Title <b>EL5 / Main / LVDS</b>		
Size Custom<Doc>	Document Number	Rev 1
Date: Tuesday, December 17, 2019	Sheet 1	of 13

Title		
EL5 / Main / DVI		
Size	Document Number	Rev
Custom<Doc>		1
Date:	Tuesday, December 17, 2019	Sheet 2 of 13

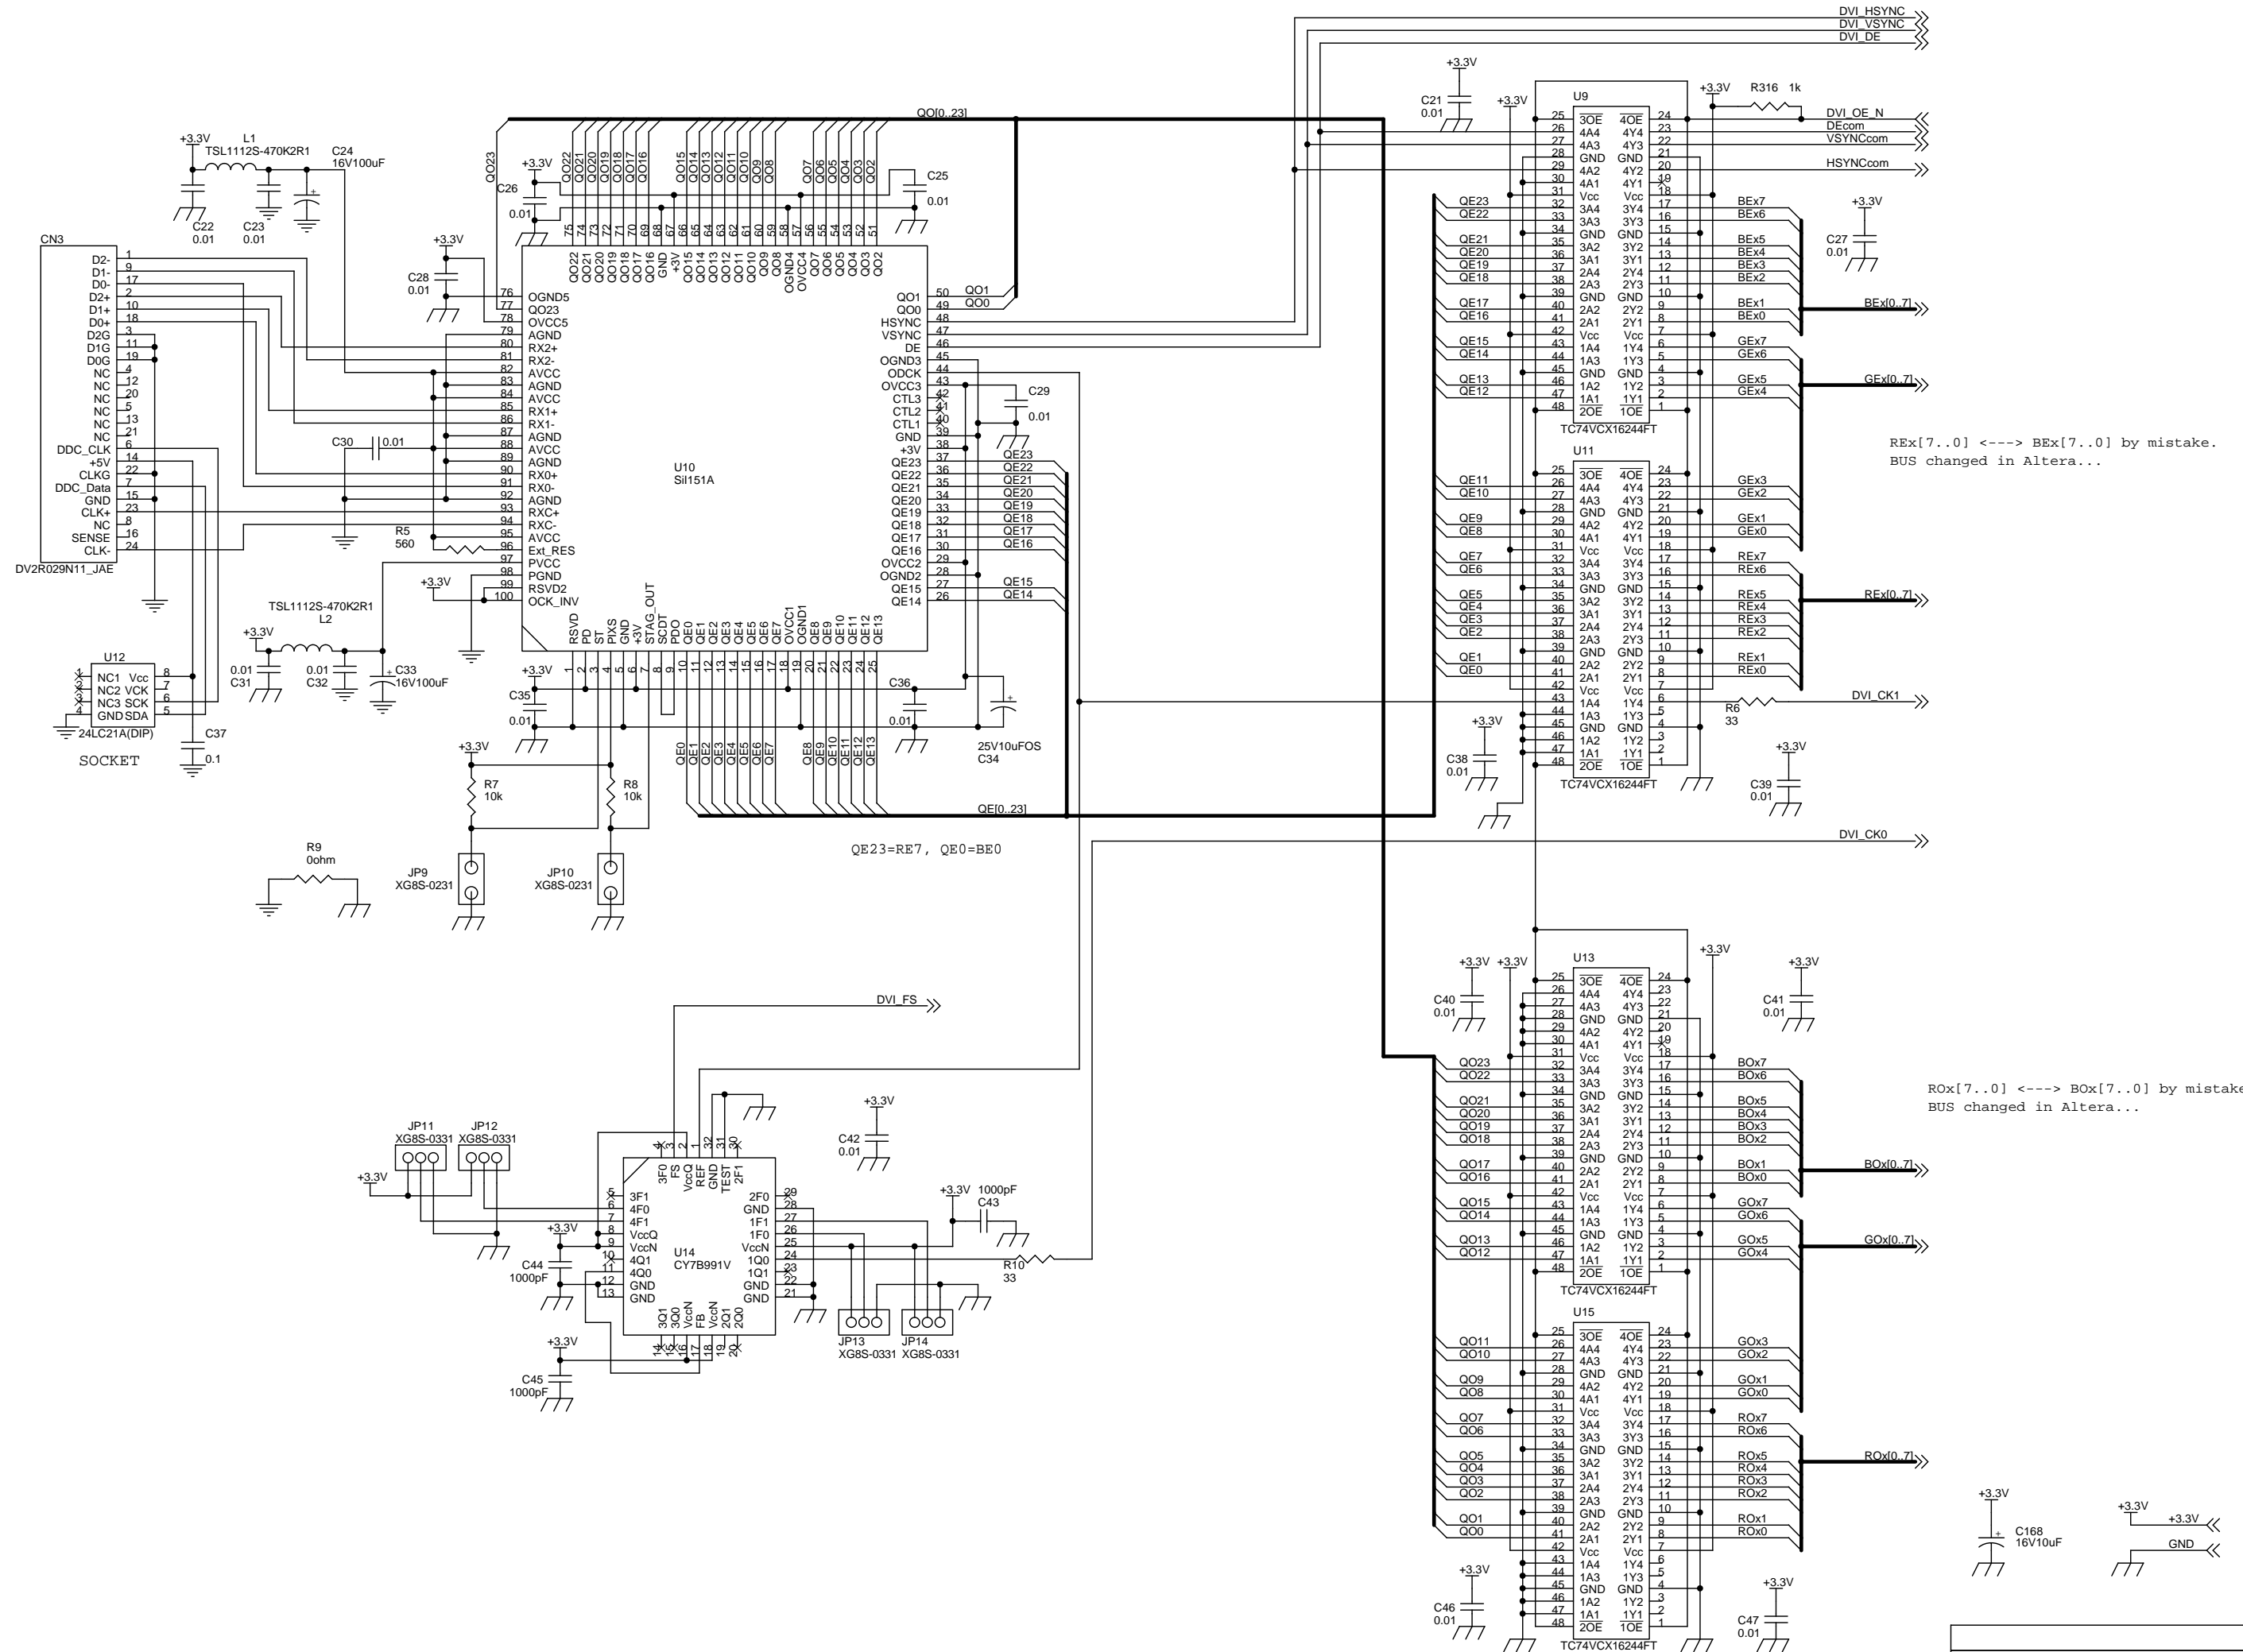
REx[7..0] <----> BEx[7..0] by mistake.  
 BUS changed in Altera...

ROx[7..0] <----> BOx[7..0] by mistake.  
 BUS changed in Altera...

Title			EL5 / Main / Altera		
Size	Document Number		Rev	1	
Date:	Tuesday, December 17, 2019	Sheet	3	of	13

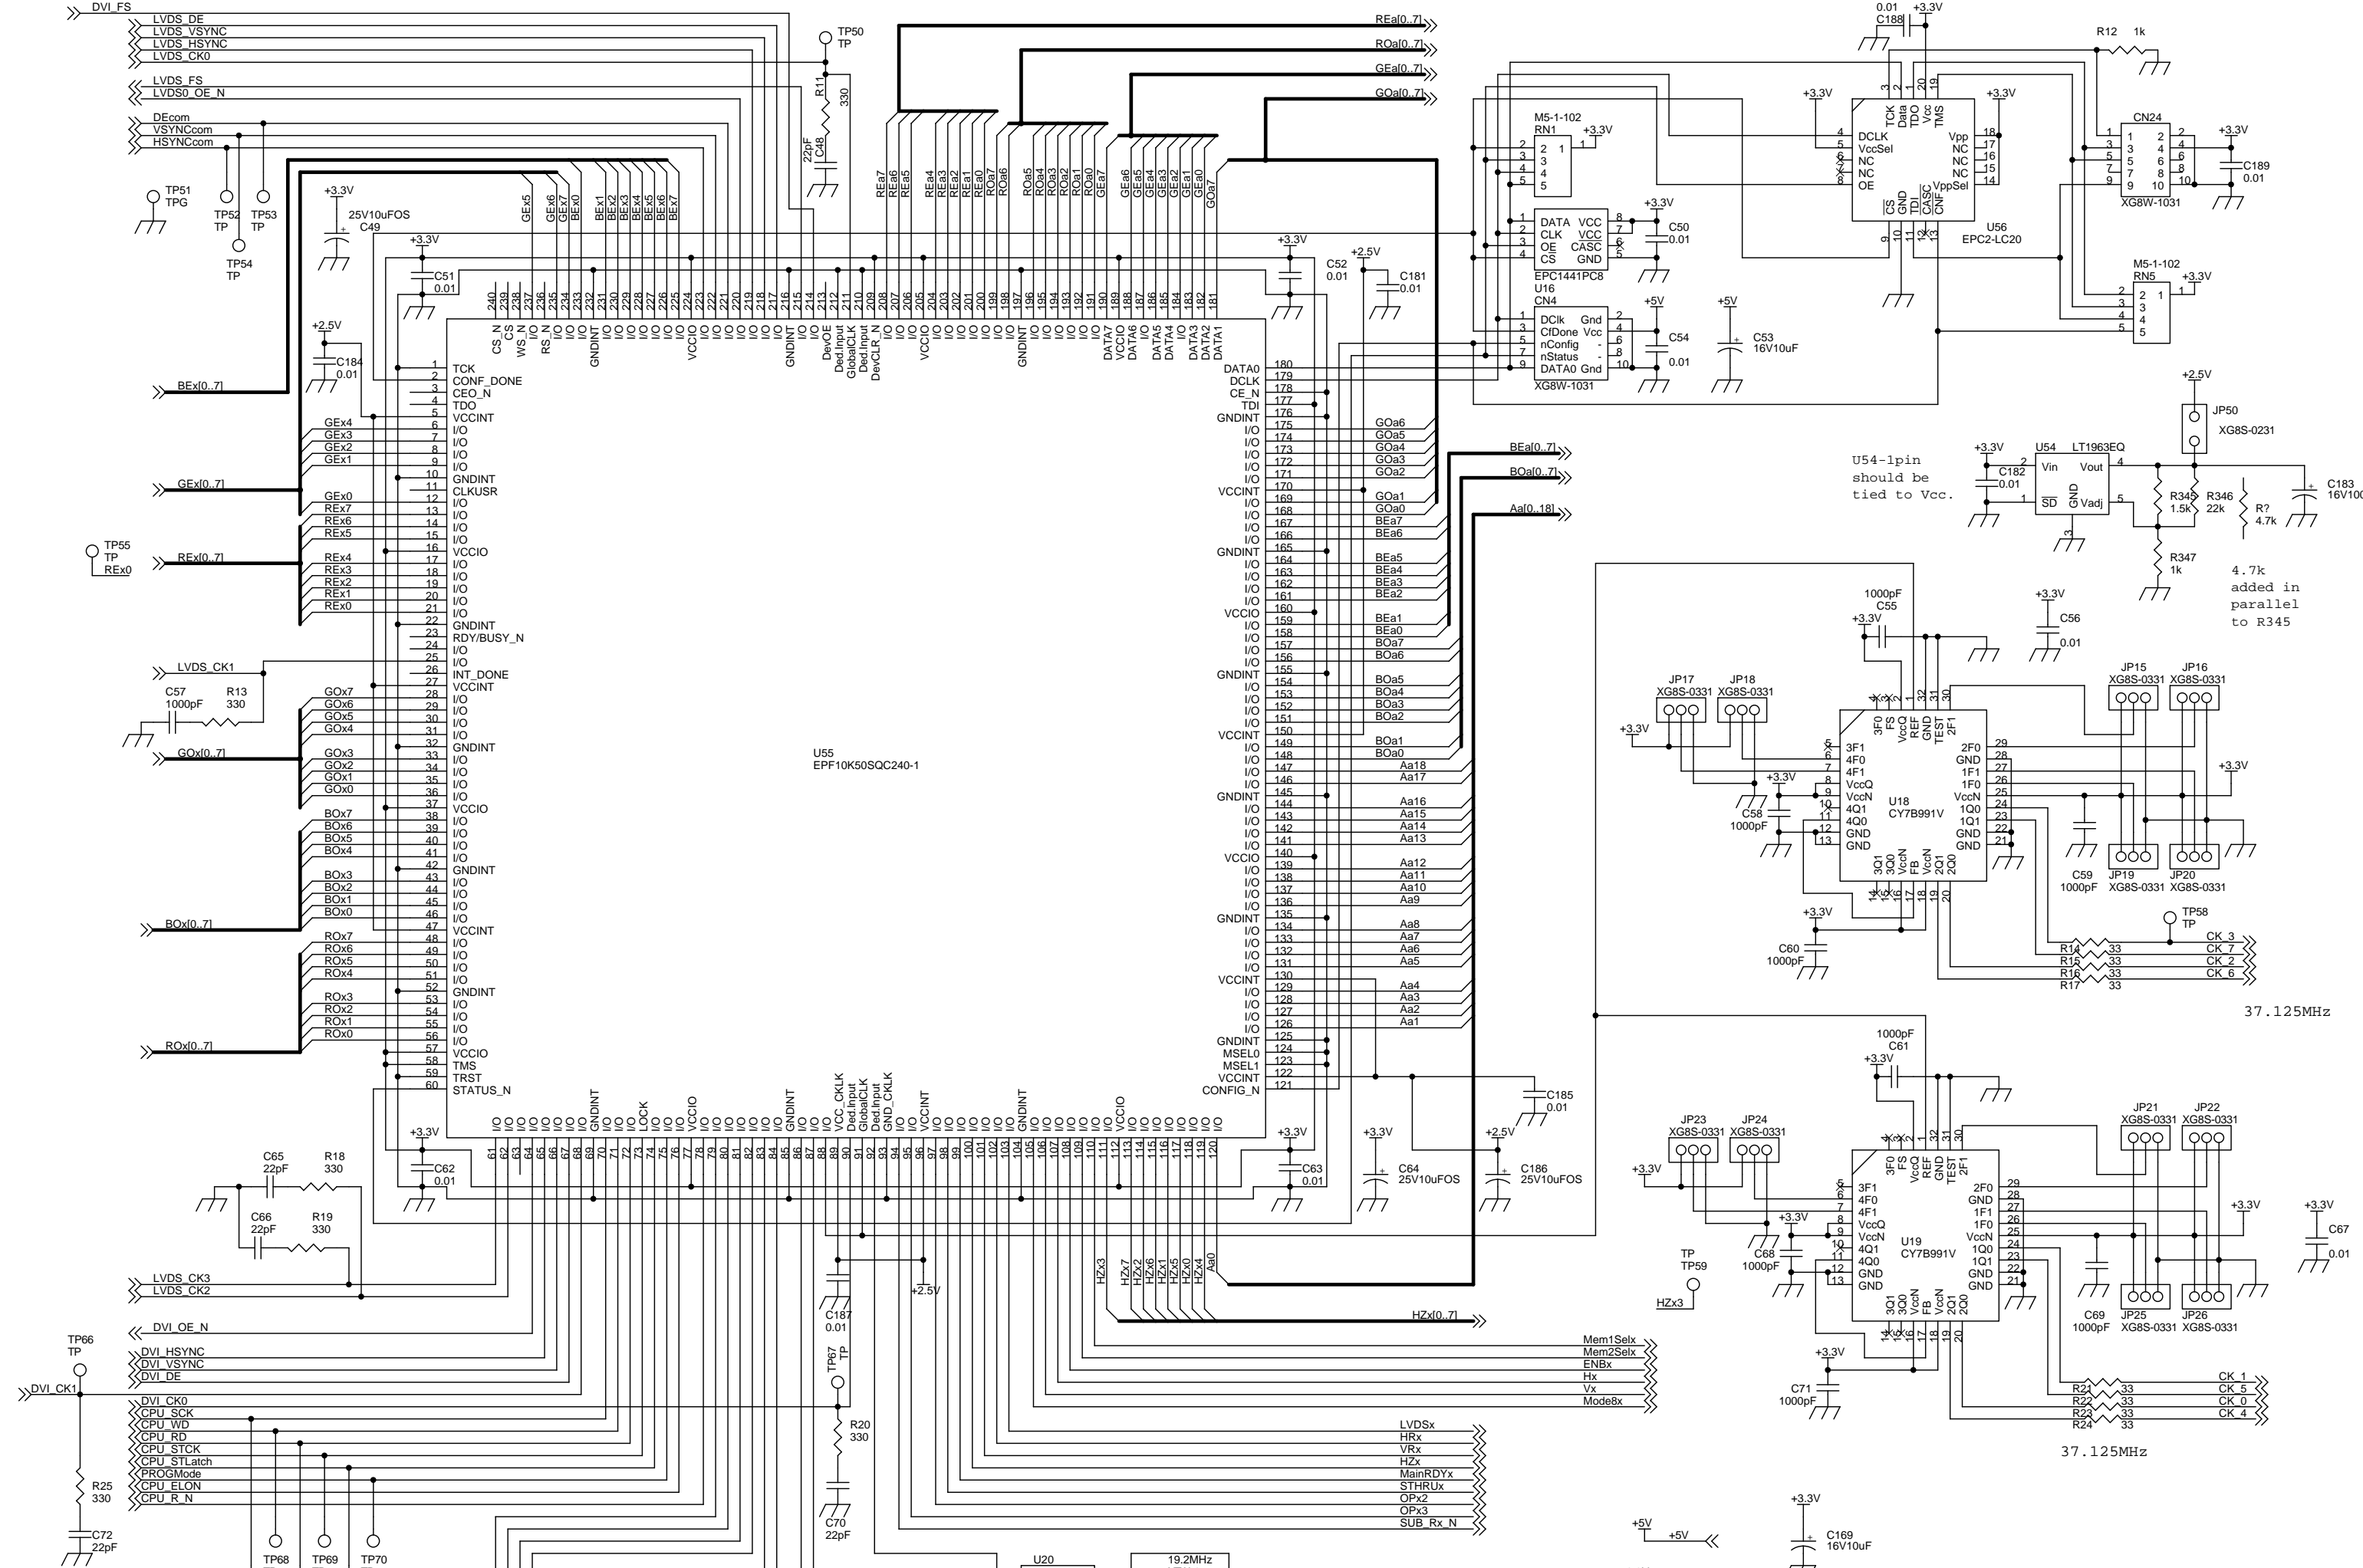
U54-1pin should be tied to Vcc.

4.7k added in parallel to R345

Title		
EL5 / Main / EL Power		
Size	Document Number	Rev
A3	<Doc>	1
Date:	Tuesday, December 17, 2019	Sheet 10 of 13

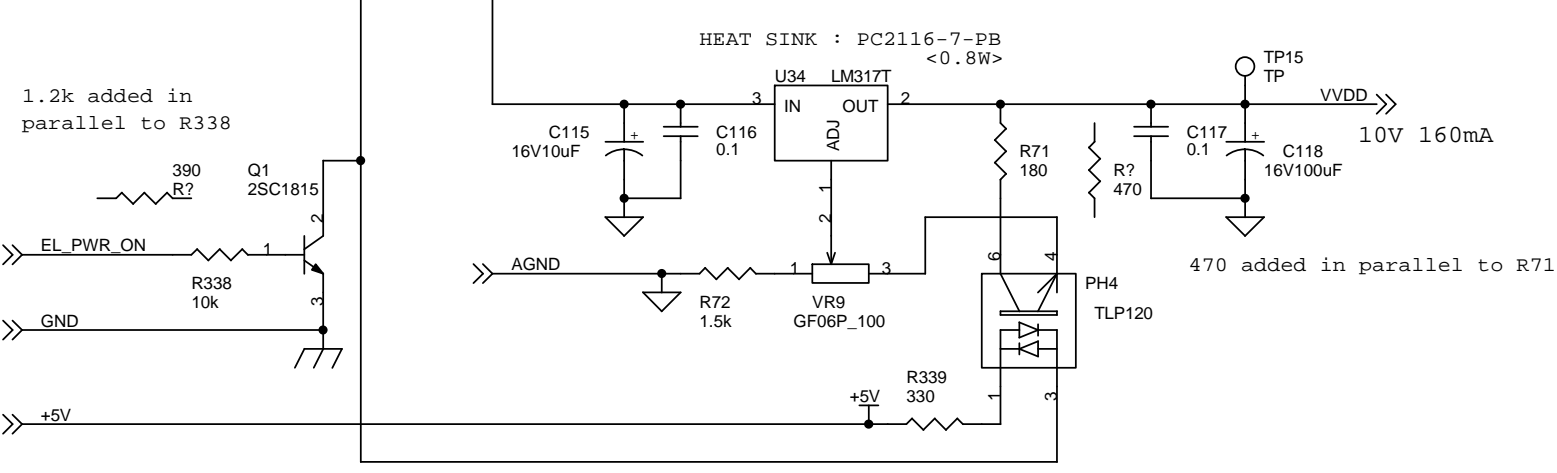
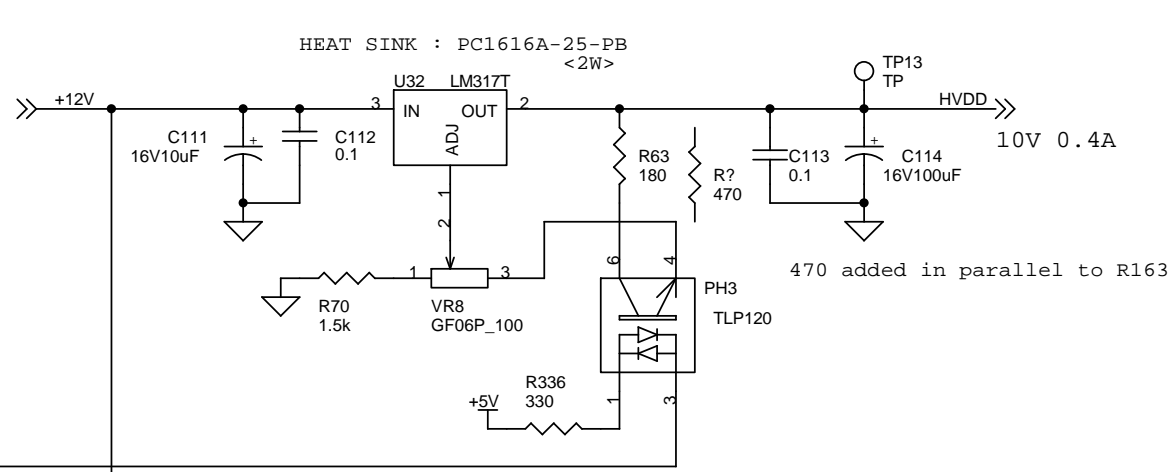
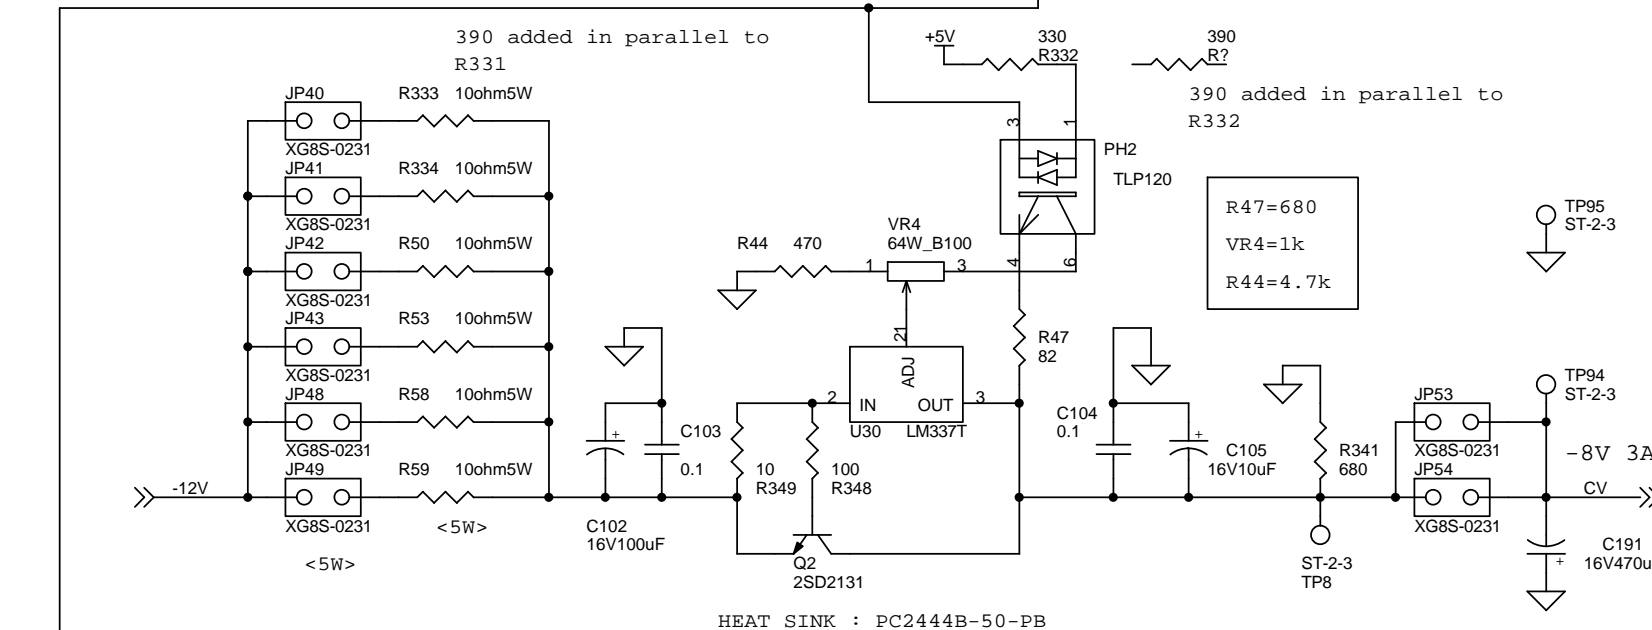
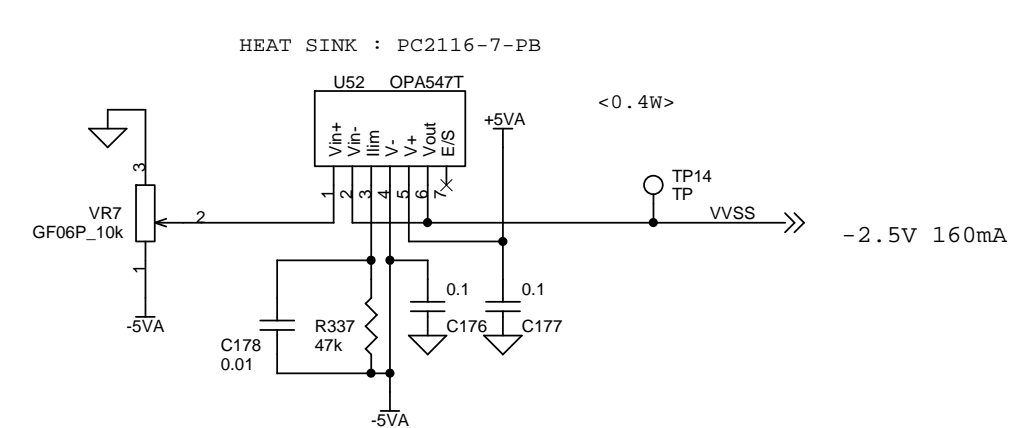
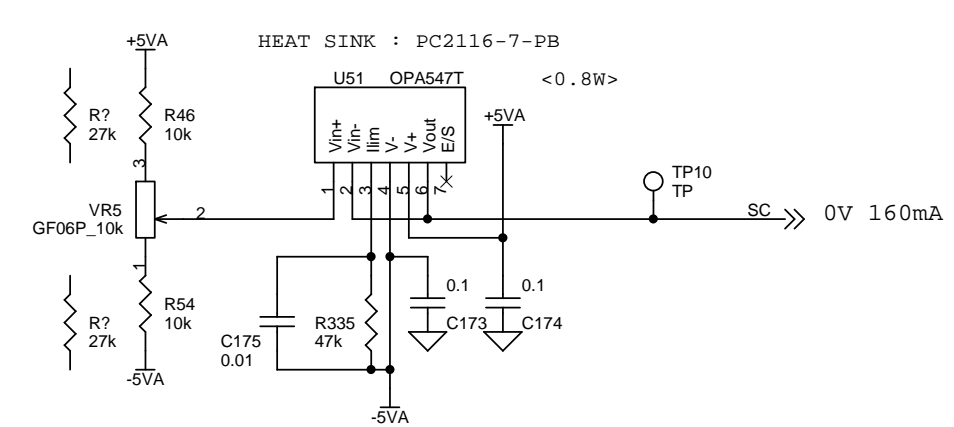
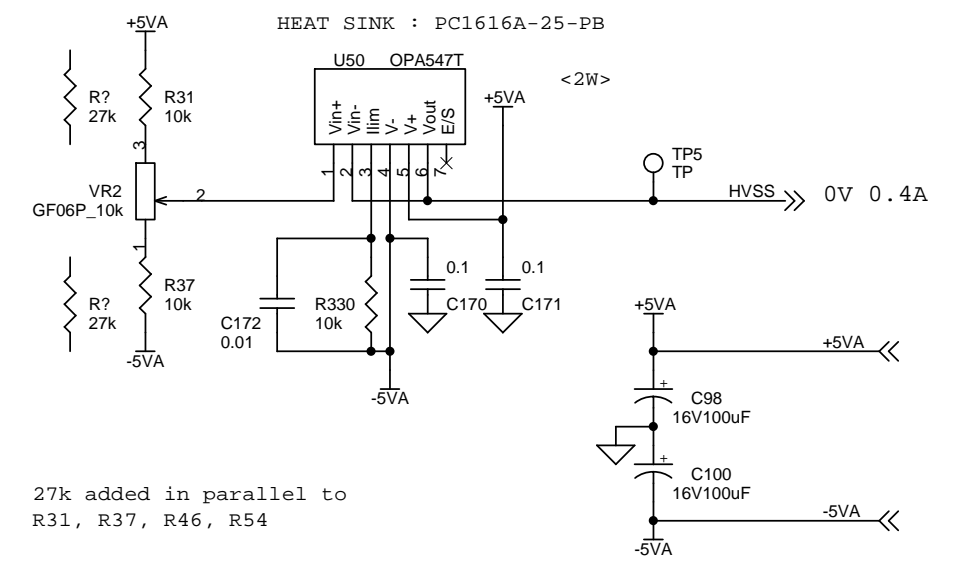
eF\_REQ\_N should not be pulled down.  
Cut RN10-9pin connection.
